SERVICE BULLETIN

#0022

SUBJECT: Replacement of improperly de-embrittled bolts

Figure 1: Sling 2 engine mount to engine frame attachment

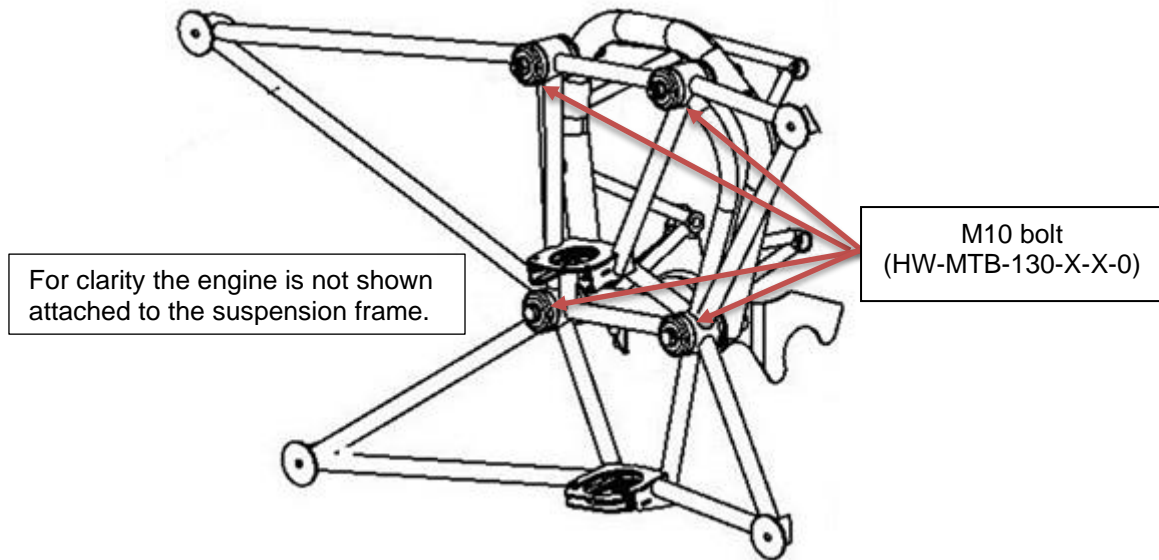
- Step 1: Before any bolts can be replaced, the aircraft's cowling needs to be removed. To do so, refer to the Sling 2 & Sling LSA Maintenance manual (DC-MAM-002-X-B) Section 5.1.1.
- Step 2: The four M10 bolts (HW-MTB-130-X-X-0) that mount the engine to the engine frame need to be replaced. These bolts can be seen in the exploded view of the engine mount in Figure 1.

It is possible to replace the M10 bolts one at a time, without uninstalling the engine.

Figure 3: Bolt replacement sequence

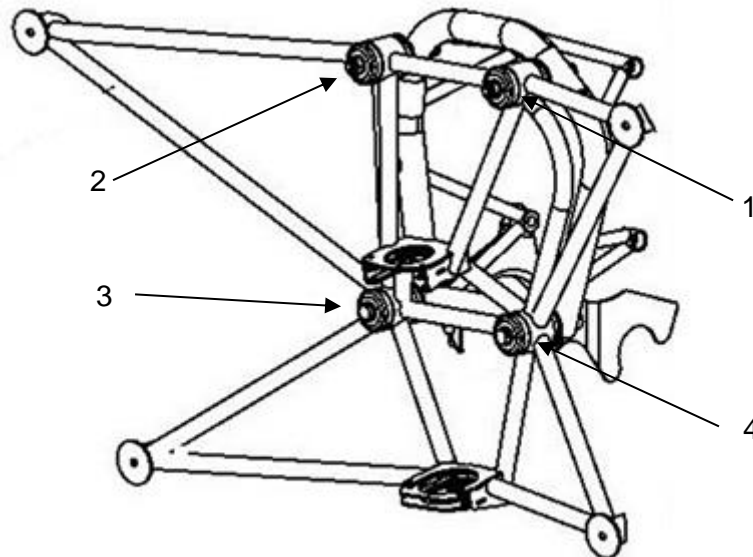
Step 4: Once the engine is supported, the bolts can be replaced *one by one*. Refer to Figure 3 and replace the bolts in order. Remove bolt 1 and install a new bolt. Torque the bolt to 38 Nm. Ensure all washers, rubber stoppers and spacers are installed in the correct positions when replacing the bolts. Once bolt 1 has been replaced and torqued to 38 Nm, replace bolt 2, which should then also be torqued to 38 Nm.

Figure 6: M8 bolts connecting the propeller extension and engine flange

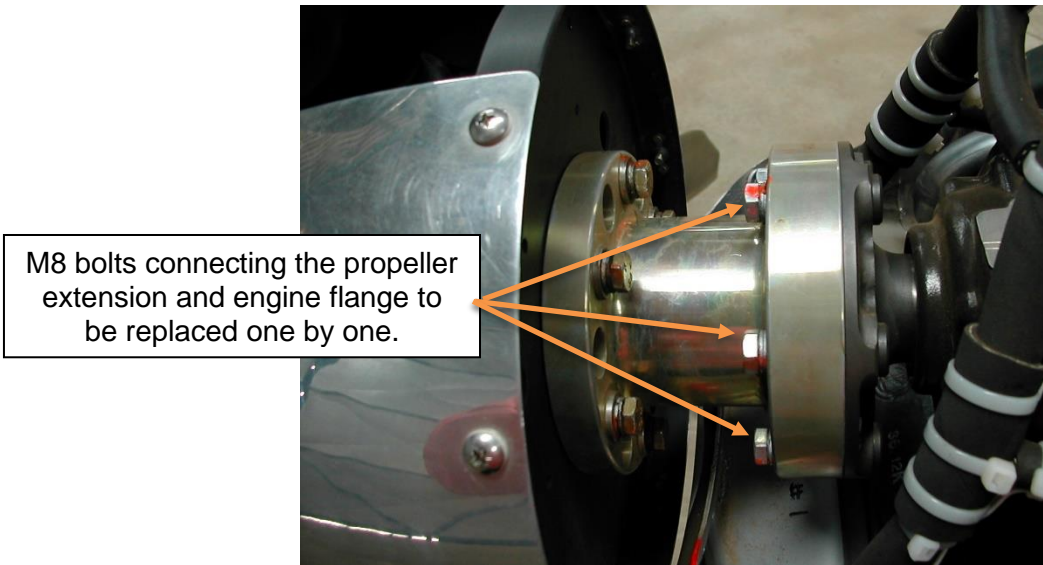
- Step 1: Before any bolts can be replaced, the aircraft's cowling needs to be removed. To do so, refer to the Sling 2 & Sling LSA Maintenance Manual (DC-MAM-002-X-B) Section 5.1.1.
- Step 2: It is possible to replace the M8 bolts (HW-MTB-840-X-X-0) without removing the propeller.
- Step 3: The bolts that need to be replaced are the M8 bolts connecting the propeller extension and engine flange. Refer to Figure 6.

Figure 7: Propeller extension bolt replacement sequence

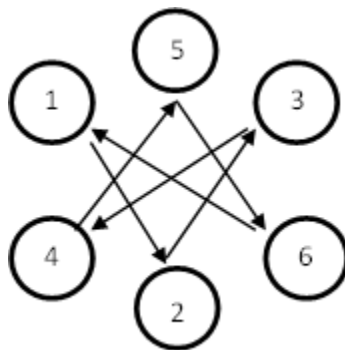
- Step 4: Support the propeller and replace the M8 bolts one by one. This will allow the propeller to remain attached during the replacement process. The bolts should be replaced in accordance with the sequence shown in Figure 7. Loctite 243 should be applied to the threaded section of each replacement bolt before it is installed. Ensure that only one bolt is replaced at a time, and it gets torqued to the correct torque value of 24 Nm, before the next bolt is replaced.

Figure 8: Sling 4 TSi engine mount to engine frame attachment

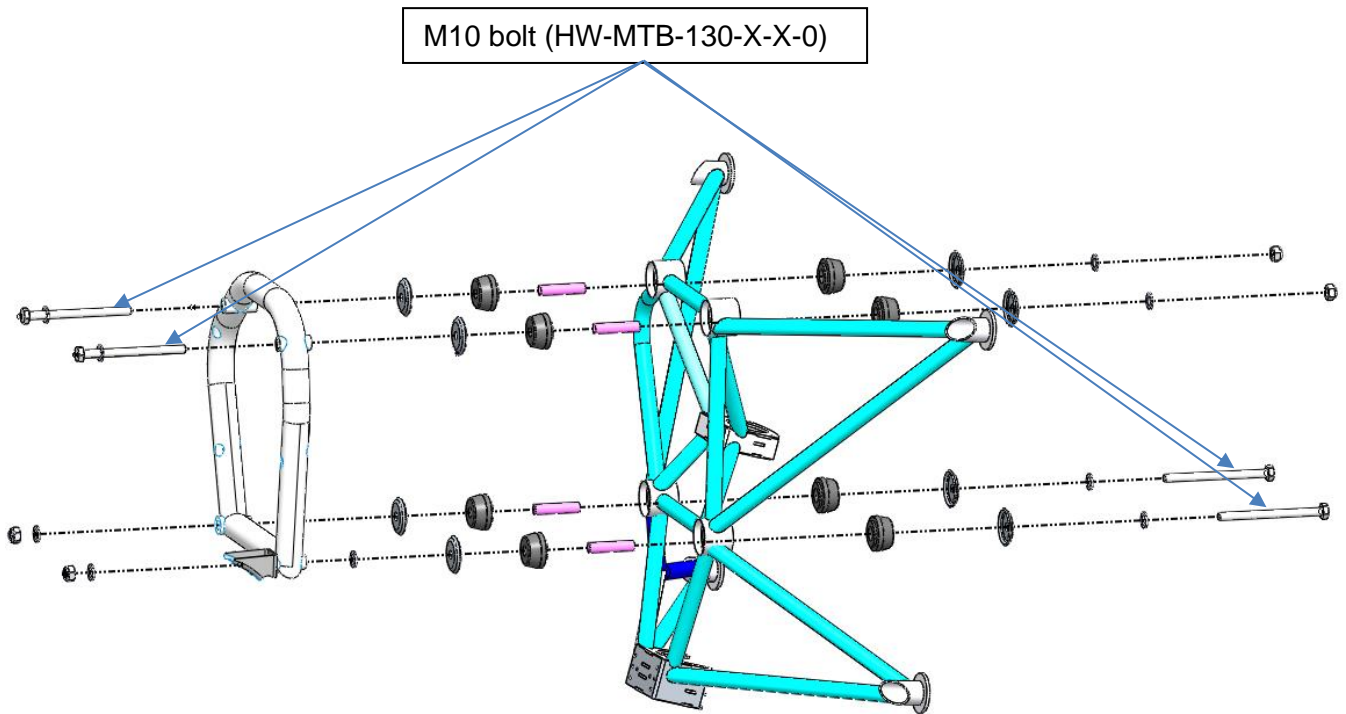
- Step 1: Before any bolts can be replaced, the aircraft's cowling needs to be removed. To do so, refer to the Sling 4 TSi Maintenance Manual (DC-MAM-001-X-F) Section 5.1.1.
- Step 2: The four M10 bolts (HW-MTB-130-X-X-0) that mount the engine to the engine frame need to be replaced. These bolts can be seen in the exploded view of the engine mount in Figure 8.

It is possible to replace the M10 bolts one at a time, without uninstalling the engine.

Figure 10: Bolt replacement sequence

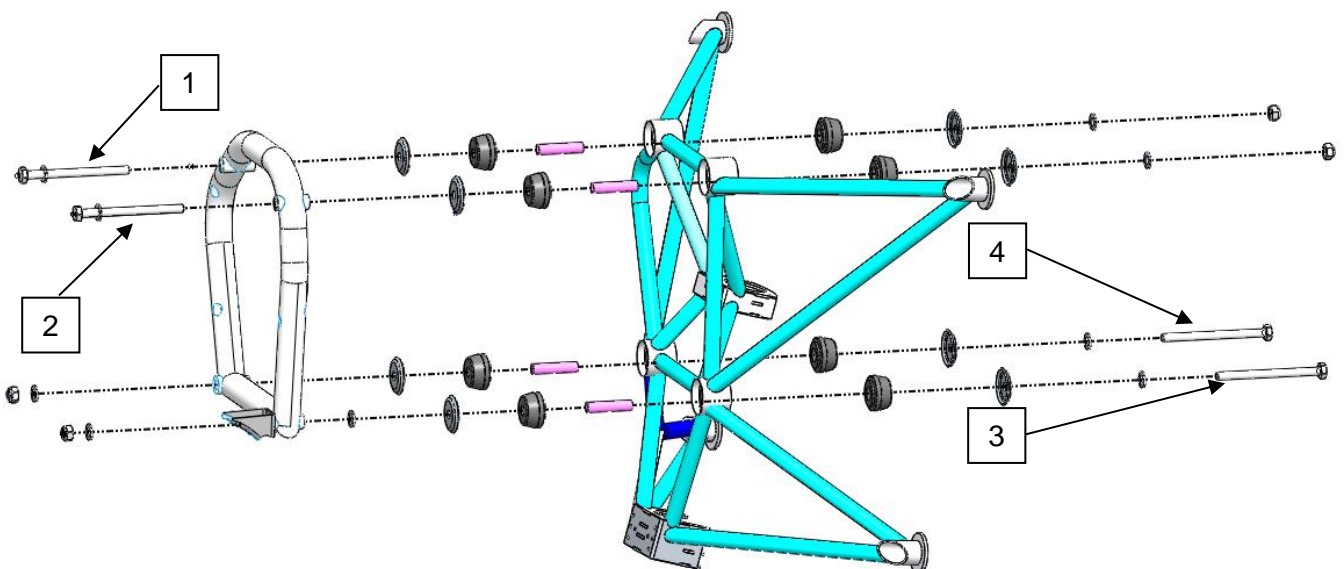
Step 4: Once the engine is supported, the bolts can be replaced *one by one*. Refer to Figure 10 and replace the bolts in order. Remove bolt 1 and install the new replacement bolt. Torque the bolt to 38 Nm. Once bolt 1 has been replaced and torqued to 38 Nm, replace bolt 2. Repeat this process until all 4 bolts have been replaced. All bolts should be torqued to 38 Nm. Ensure all washers, rubber stoppers and spacers are installed in the correct positions when replacing the bolts, as seen in Figure 10. The muffler of the Sling 4 TSi does not need to be lowered in order to replace the M 10 bolts shown in Figure 10.
